Niagara-on-the-Lake Hydro Inc.

Application Analysis (EB-2016-0095)

NOTL Responses

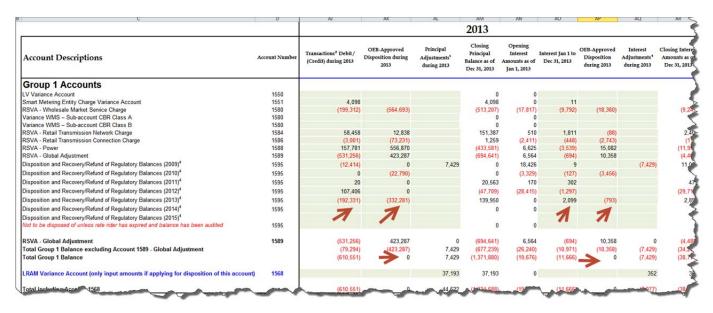
OEB staff notes Niagara- on-the-Lake Hydro has been putting Account 1595 as an offset but in 2013 it did not, please explain.

• NOTL inadvertently keyed in cell AJ34 the entire net change of \$139,950 for 1595 (2013) in the year 2013. This change comprises the following and should have been keyed in accordingly:

- A similar error was made for interest.
- The IRM model has been updated to reflect these corrections (and to reflect the LRAMVA adjustment per Question 9). The updated entries are shown below:
